Address: Nos. 134 – 144 Pitt Street, Redfern
Proposal: Mixed Use Development
OCTOBER 2017

RESPONSE TO SUBMISSIONS

RESPONSE TO SUBMISSIONS
FORMER RACHEL FORSTER HOSPITAL
NOS. 134 – 144 PITT STREET, REDFERN

PREPARED FOR KAYMET CORPORATION PTY LTD

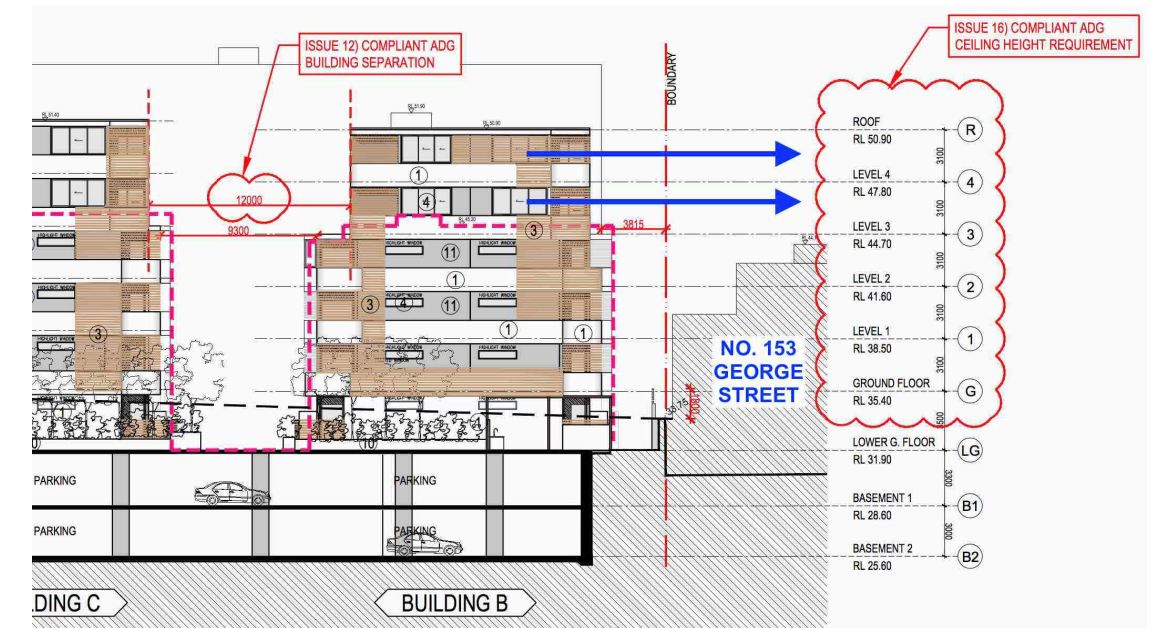
- *Reduce amenity impacts to neighbouring properties to the west of the site;*
- *Provide improved amenity to future occupants within the site; and*
- *Maintain an appropriate curtilage to Building A.*

Reduce amenity impacts to neighbouring properties to the west of the site;

Recommended building separations are not achieved between the introduced upper levels of Building B and the recently completed building at No. 153 George Street. The proposed modifications do not however introduce windows into any elevation in which they were not previously approved. The increase in height of Building B will not therefore significantly contribute to overlooking of this property, which is built to boundary, oriented to the north and south, and has limited openings upon its eastern elevation (see **Figures 12 – 14** over page).

living area and master bedroom are oriented to the north. The 3 lower levels of this residential building are oriented north and south only. As can be seen in **Figure 13**, the additional Levels 3 and 4 proposed atop Building B are at a level where there will be no direct privacy conflict with No. 153 George Street, given the height and offset nature of the proposed new windows, and the limited number of windows upon the eastern elevation of the established development at No. 153 George Street (see **Figures 12 and 14**).

Figure 15

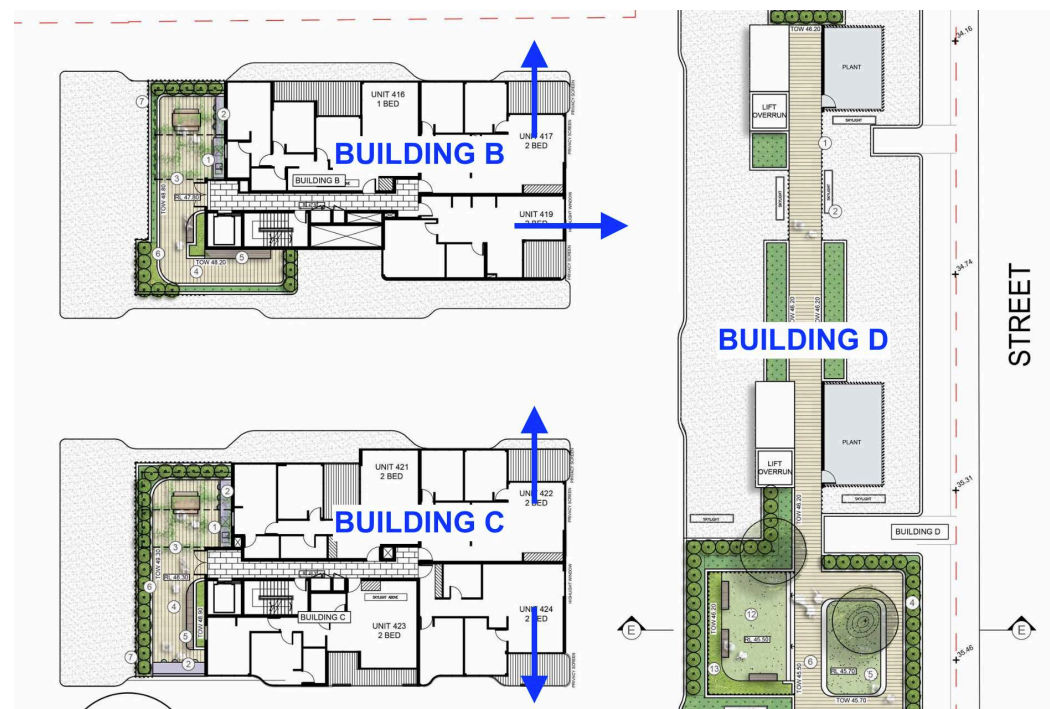
Provide improved amenity to future occupants within the site;

Through orientation of the living rooms, fenestration, changes in building level and incorporation of landscape screening to the communal open space atop the roof of Building D, the setbacks between Buildings B and C to Building D raise no issue in relation to privacy separation (see **Figure 15** below).

Separation of Building's B and C to Building D at the upper levels.
